From: jacson99@aol.com
Sent: Tuesday, October 19, 2010 10:14 AM
To: Comanche COLEIS Resource
Subject: Fwd: LGWOA Response to NRC Environmental Impact Study
Attachments: Trungale_Report_Commanche_Peak.pdf; downstream_letter_.pdf.pdf; 05[1].06.10_BRA_Interim_Order(4).pdf; 06[1].08.10_Order_No._1(2).pdf

We have thoroughly reviewed the U.S. Commission's Draft Report for Comment, published in August 2010, concerning Luminant's application for licensing of the Comanche Peak Expansion 3 and 4. Our research here at LGWOA, finds that the water level impact study on Lake Granbury and the Brazos River Basin has not been thoroughly reviewed, and there were other studies that were not considered.

Federal Register Notice: 75FR48998
Comment Number: 53

Effects of diversions for the Comanche Peak Nuclear Project on the ecological health of the Brazos River

Figure 1 Frequency of failing to meet targets under natural, current and proposed flow conditions

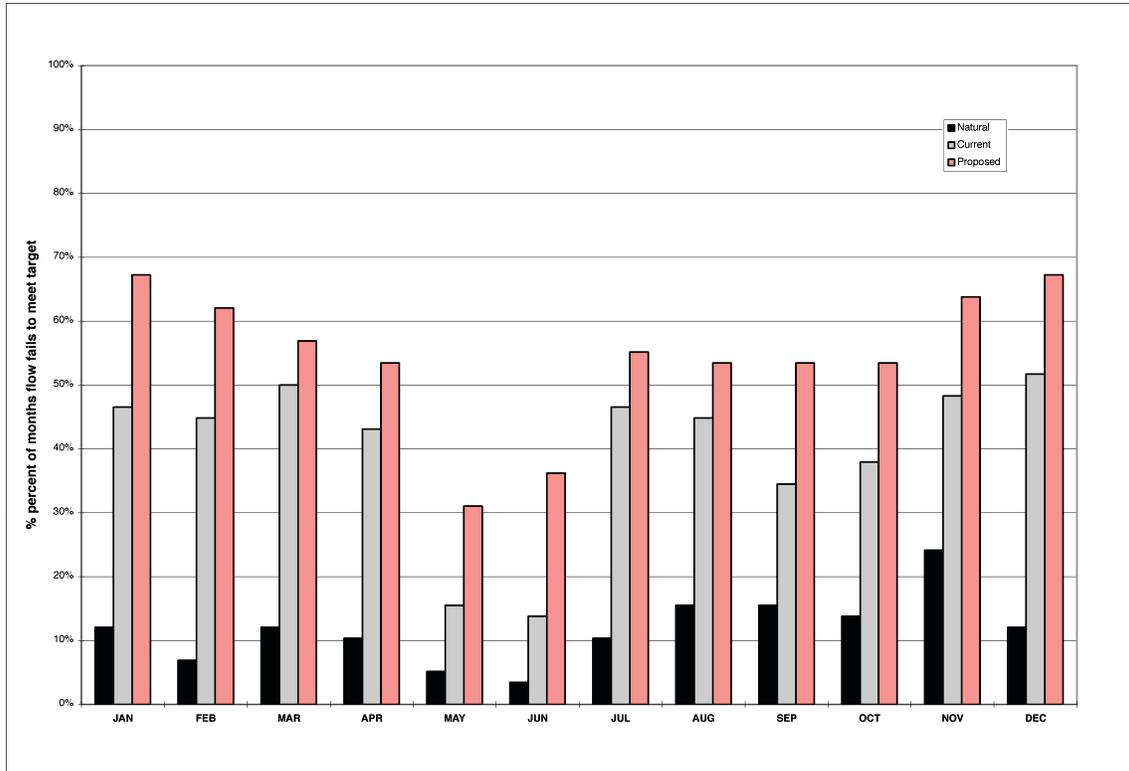
Finally the frequency of failing to meet the necessary flow conditions would be substantially increased with the implementation of the proposed water development plans need to supply water for the Comanche Peak project. Frequency of drought conditions is defined as the number of months in which the target flows are not meet. These frequencies are presented in Figure 1 as the percent of months over the 56 year WAM simulation period during which the flows would be expected to be below recommended levels. Clearly there are times when even under natural conditions the targets would not be satisfied, however these occurrence which would have been relatively infrequent (about 10% of the time) under the natural flows will become the dominate condition under the proposed plans.

As the preceding analysis demonstrates, the consumptive water use needed to expand the Comanche Peak project will result substantial increases in the frequency, duration and severity of failing to meet target environmental flow needs. Rather than resulting in a small impact as the applicant contends, increase diversions have the potential to have significant, negative impacts on the ecological health of the Brazos River.

Figure 4B.12.1-1. Cedar Ridge Reservoir

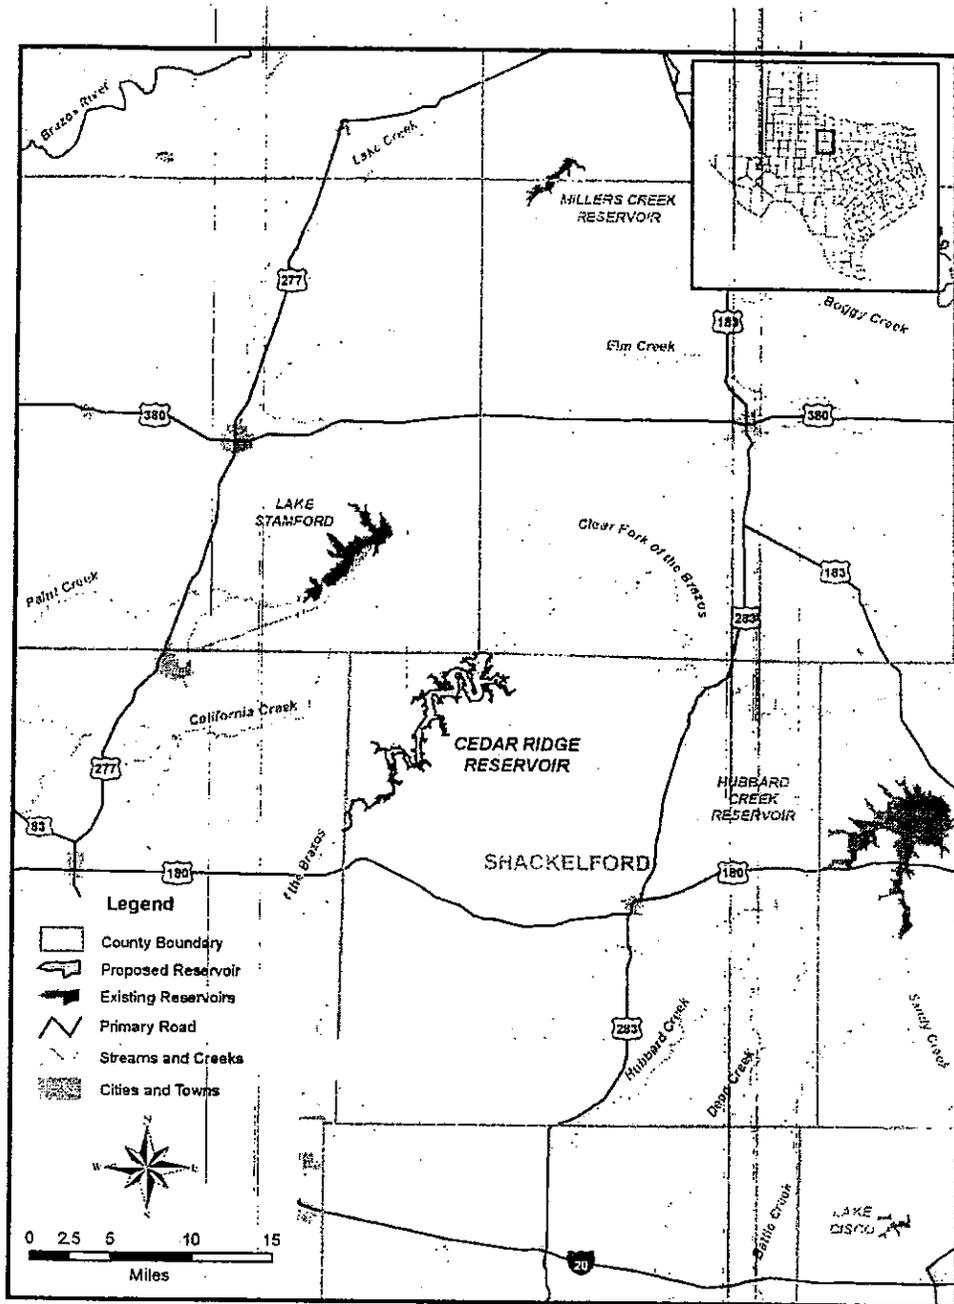
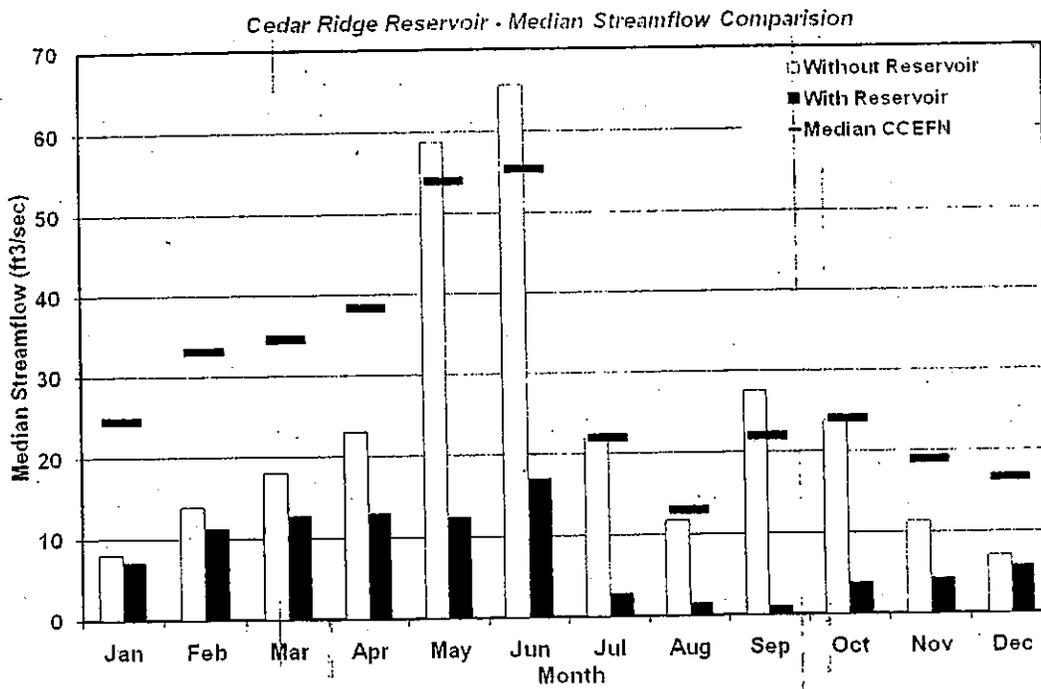
Please see attached Table 4B.12.1-2 (Median Monthly Streamflow: Cedar Ridge Reservoir) and Figure 4B.12.1-3, "Cedar Ridge Reservoir – Median Streamflow Comparison." This information is taken from the Initially Prepared 2011 Brazos G Regional Water Plan submitted to the Texas Water Development Board (www.twdb.state.tx.us). These tables show the *median* (not the average) flows for the Clear Fork. The median means that flow levels are above the median half the time and below the median half the time. Operators of the dam would be required to match the historic *minimum* flows of the river, which drop to 0.73 cubic feet per second (cfs) 16% of the time and to zero flow 8.9% of the time. The tables show, however, that withdrawing 22 million gallons per day from the Clear Fork would significantly reduce flows above that historic minimum.

The Brazos G Regional Water Plan states, "*These lower stream flows would have substantial impacts on the instream biological community in areas downstream of the project site. Substantial reductions in July, August, and September would be particularly detrimental as a result of high temperatures and the high likelihood of impairment of other water quality parameters during this time of year.*" The Plan further states that, "*The anticipated impact of this project would be lower variability in and significant reductions in the quantity of median monthly flows.*" Additionally, the Plan says that "*Variability in flow is important to the instream biological community as well as riparian species and this reduction could influence the timing*
